PROPOSED RESIDENTIAL DEVELOPMENT, LAND AT STONEY LANE, WHISTON – RESPONSE TO ACTIVE TRAVEL ENGLAND – MAY 2026

- 1 Eddisons have been instructed by Taylor Wimpey to advise on the traffic and transport issues relating to a planning application for the former Glen Dimplex Site in Whiston. (Planning Ref: 25/00672/FUL).
- 2 This Transport Note has been produced in response to the consultation response received from Active Travel England (ATE) dated 2nd March 2026.

Proposed Site to Prescott Town

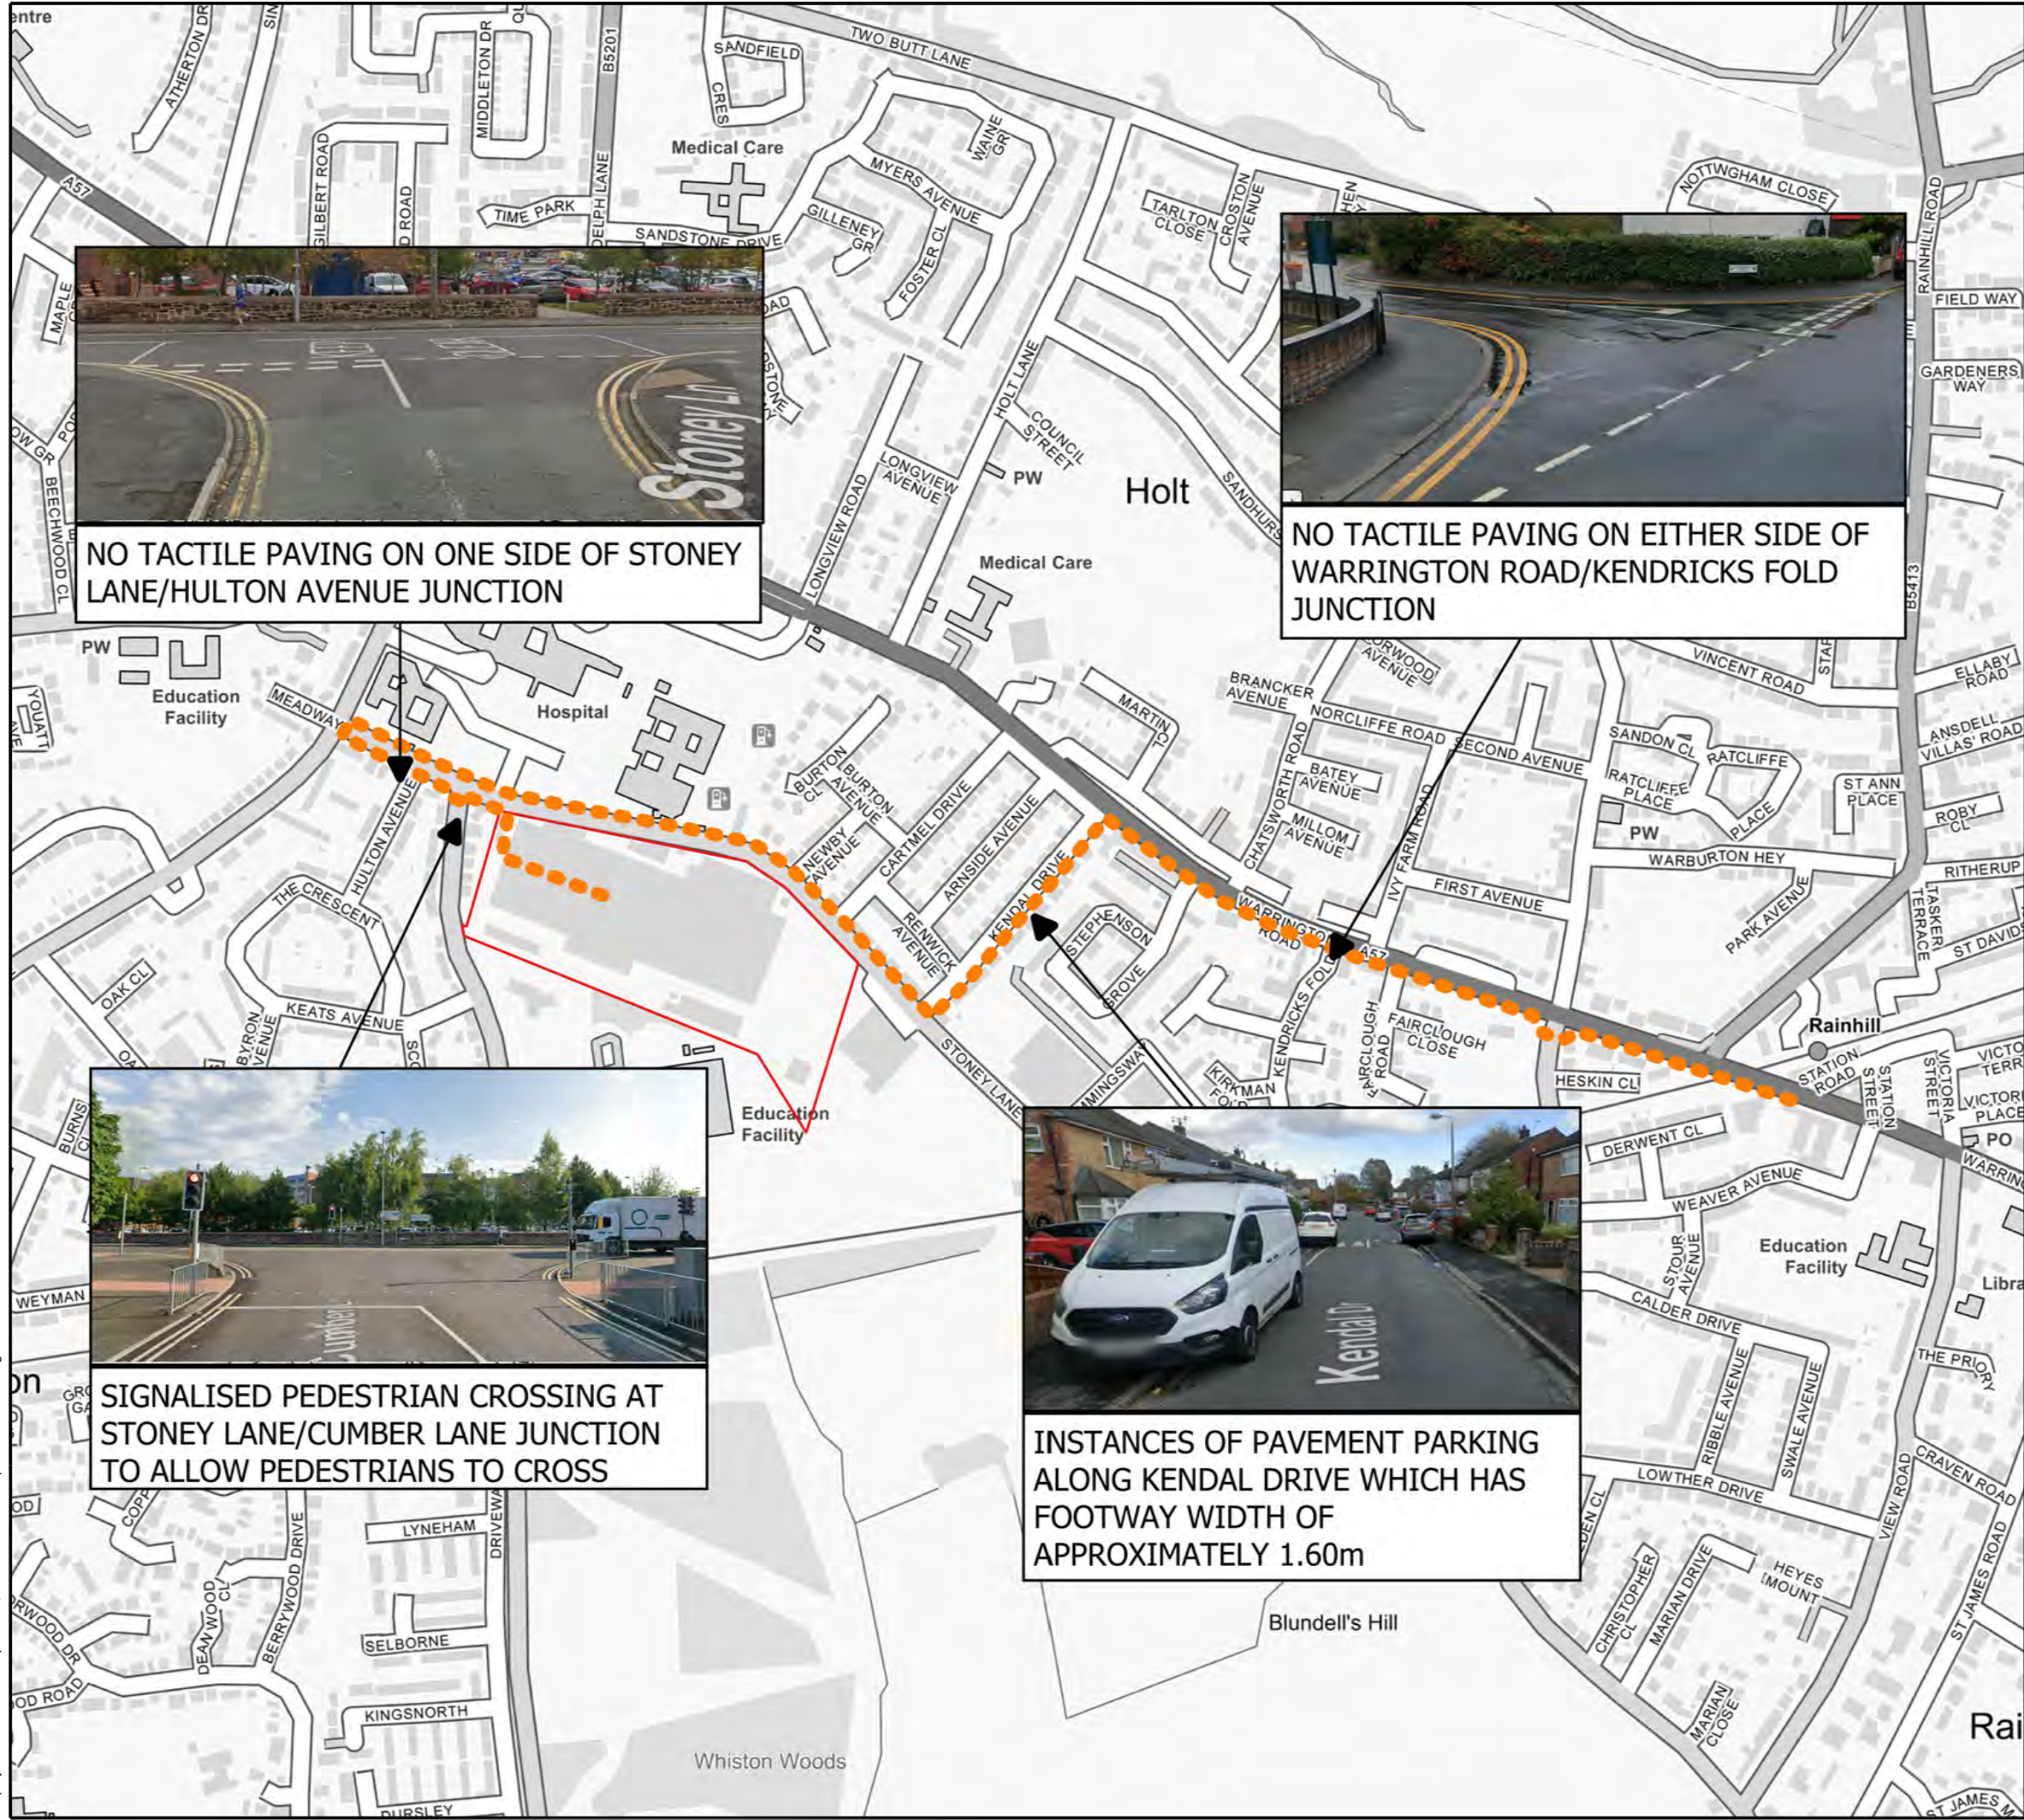
NO TACTILE PAVING ON ONE SIDE OF STONEY LANE/HULTON AVENUE JUNCTION

NO TACTILE PAVING ON EITHER SIDE OF WARRINGTON ROAD/KENDRICKS FOLD JUNCTION

INSTANCES OF PAVEMENT PARKING ALONG KENDAL DRIVE WHICH HAS FOOTWAY WIDTH OF APPROXIMATELY 1.60m

Comments	The route is generally direct and well connected, with good footway provision and crossing facilities. Whilst sections along the A57 Warrington Road experience moderate traffic and noise, this is typical of an urban environment and does not significantly impact the overall quality of the route.
Actions	No off-site improvements are proposed at this stage.
